AVIATION TECHNICAL BULLETIN

NO. 75-1

THE MODEL 2400 DRY ABRASIVE CLEANER

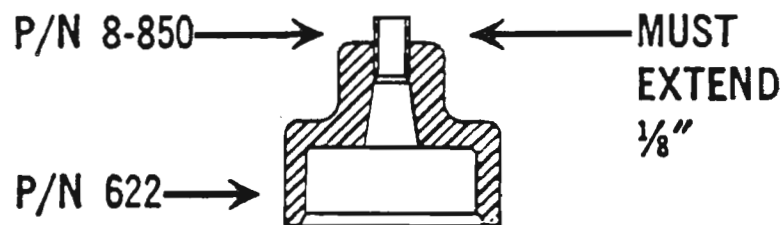
Recently, Champion Spark Plug Company was notified that the new Model 2400 Dry Abrasive Cleaner did not function properly, due to poor cleaning action.

Investigation of this cleaner indicates the problem involves the positioning of the heavy duty nozzle tip, Part No. 8-850 in the rubber nozzle tip, Part No. 622. In most cases, the carbide tip is positioned too far into the rubber tip.

Please refer to the following illustration:

Repositioning of the carbide tip as illustrated above will correct the poor cleaning action problems.
